July 30, 2013
NND-13-0417
10 CFR 50.90

Virgil C. Summer Nuclear Station (VCSNS) Units 2 and 3
Combined License Nos. NPF-93 and NPF-94
Docket Nos. 52-027 & 52-028

Subject: LAR 13-13 Request for License Amendment:
Changes to the Structure and Layout of the Turbine Building

**Floor Response Spectra Associated with Request for License Amendment
Regarding Changes to the Structure and Layout of the Turbine Building**

Figure 5-1: 2D SASSI North-South Model in X Direction

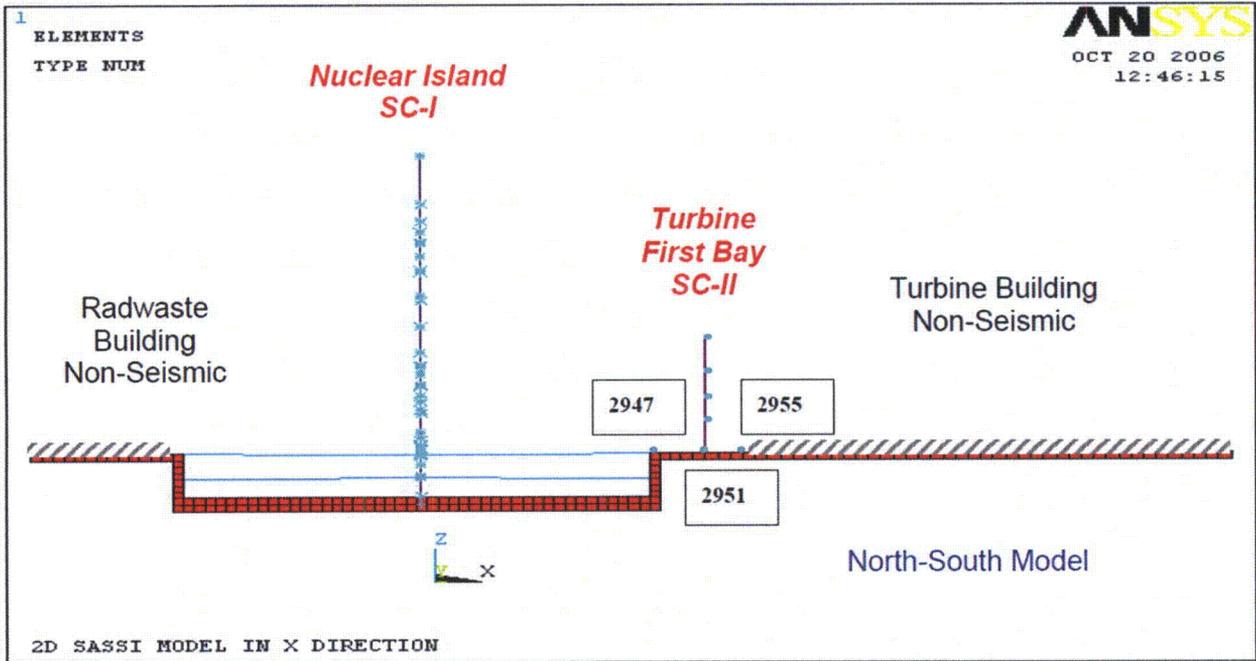
Soil-structure interaction analyses were performed to assess the change in the height and thickness of the first bay walls. The analyses were performed using the SASSI 2000 computer code which has been validated for AP1000 calculations. The two-dimensional (2D) analyses were performed using the V. C. Summer best estimate soil profile and seismic input. Updated building properties were used. The resulting seismic floor response spectra (FRS), soil pressures and basemat stresses for the appropriate nodes and elements of the Turbine Building model were obtained. Figures showing the floor response spectra (FRS) at the three locations of interest and a comparison to the generic AP1000 envelope are provided in Enclosure 5. Note that direction "X" as depicted in these figures corresponds to the North-South line. The results show that the V.C. Summer FRS are enveloped by the generic AP1000 FRS. As seen from these spectra, there is an exceedance in the range of 11.5 Hz and 13 Hz. As a result of this exceedance, a stress comparison was made with the AP1000 2D generic stresses, and it was shown that the V. C. Summer site specific stresses are enveloped by the AP1000 generic stresses. Consequently, this exceedance has no design consequence for the Turbine Building first bay. Relative displacements at the base and top of the adjacent structures indicate that there is no contact between the structures at the foundation and the superstructure. This analysis, with the proposed Turbine Building changes incorporated, also confirmed the previous assumption for the three-dimensional (3D) SASSI analysis of the Nuclear Island structures, that the effect of adjacent structures on the Nuclear Island is small and can be neglected.

This activity will not adversely affect the Turbine Building's seismic response, because the calculated FRS, as shown in the attached figures, are, with the exception of the exceedance discussed above, enveloped by the generic AP1000 spectra. The first bay will continue to maintain a seismic Category II rating and compliance with the seismic design criteria of GDC 2 for the seismic Category II first bay is not affected.
